STATE OF WASHINGTON
DEPARTMENT OF ECOLOGY

Re: Further Action at the following Site:

- **Site Name:** Shell Station 121771
- **Site Address:** 22026 Marine View Drive South, Des Moines
- **Facility/Site No.:** 88387929
- **VCP Project No.:** NW2081

Issue Presented and Opinion

Approximate Boundary of Site

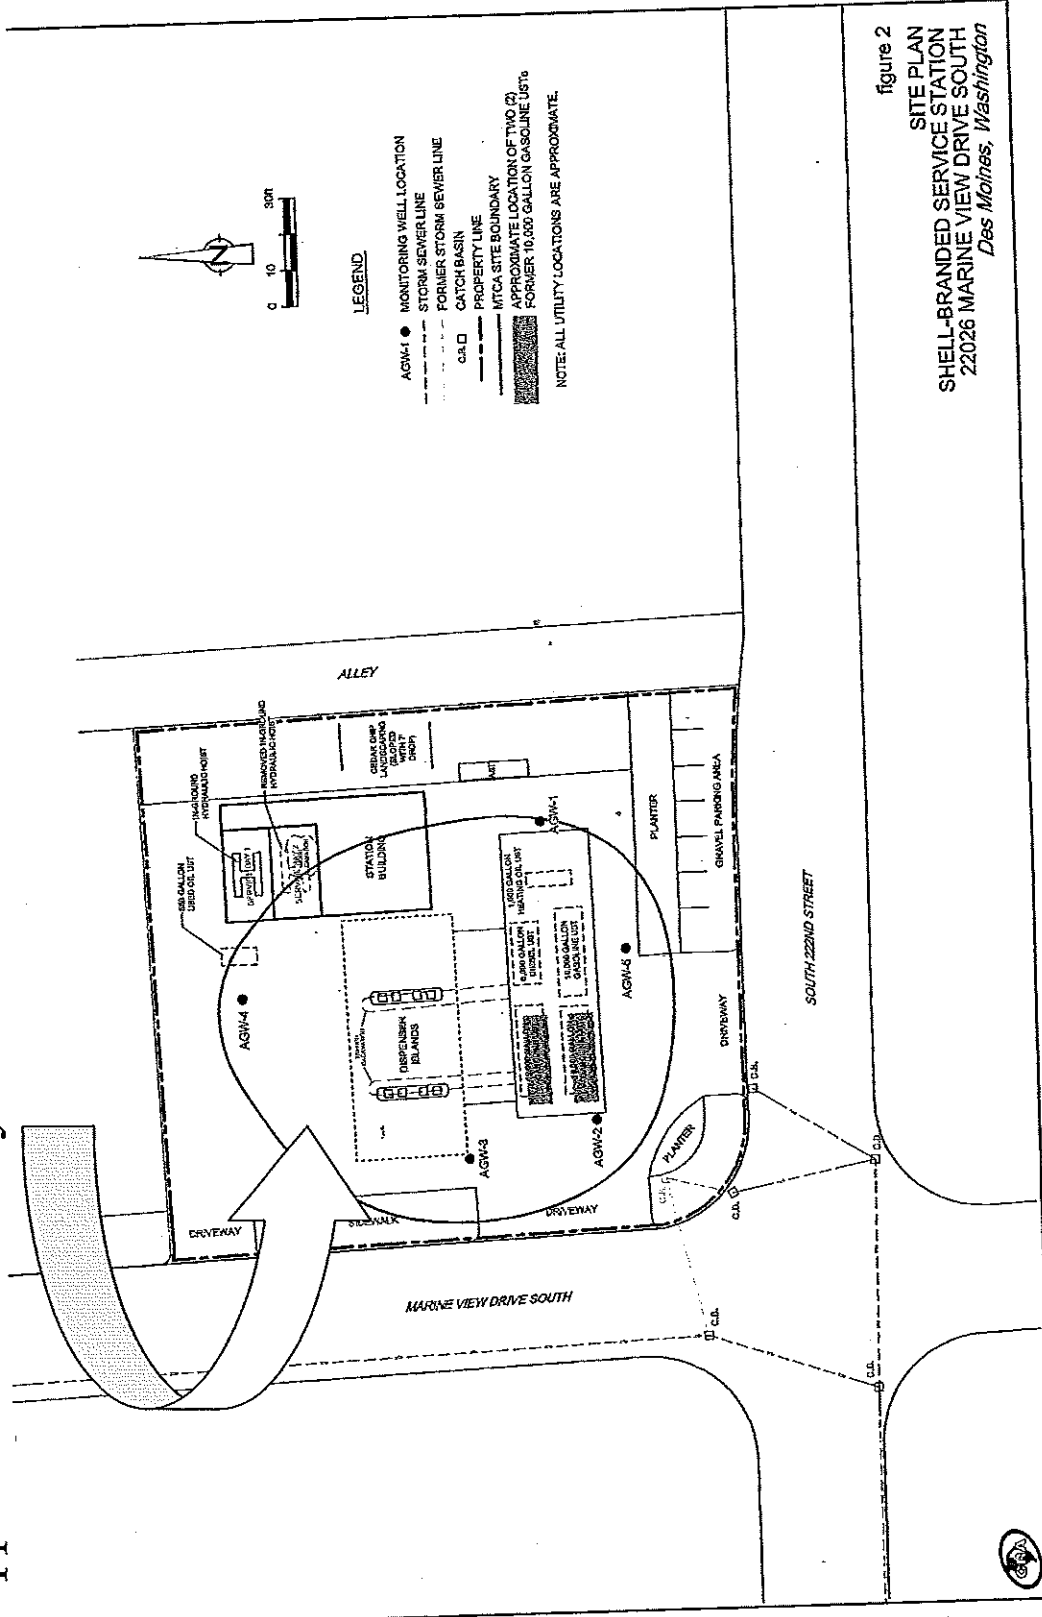
Ecology has determined your characterization of the Site is not sufficient to establish cleanup standards and select a cleanup action. The Site is described above and in **Enclosure A**.

Investigations conducted at the Site indicate that monitoring wells AGW-1 through AGW-5 are appropriately placed to monitor ground water contamination associated with releases near the dispenser islands and tank nest area. The TPH ground water plume does not appear to be adequately characterized at the Site. Ground water samples collected in February, March, and April 2009 indicate that elevated levels of benzene were observed at monitoring wells AGW-2, AGW-3, and AGW-5 with observed levels of TPHg and benzene above MTCA Method A cleanup levels at AGW-3. The cause of these elevated levels needs to be identified to determine if it was due to a recent release, contaminated soil that remains in the vicinity of the dispenser islands, or contaminated soil that has not been identified.

The vertical and lateral extent of soil contamination near the dispenser islands needs to be better characterized. Soil samples collected in 1995, did not identify the maximum depth of soil contamination in this area. Confirmation soil samples need to be collected in areas where previous soil samples showed TPHg, TPHd, and BTEX in soil exceeded MTCA Method A cleanup levels to determine if natural attenuation remediated the chemicals of concern in soils and contamination has not migrated in the soil column.
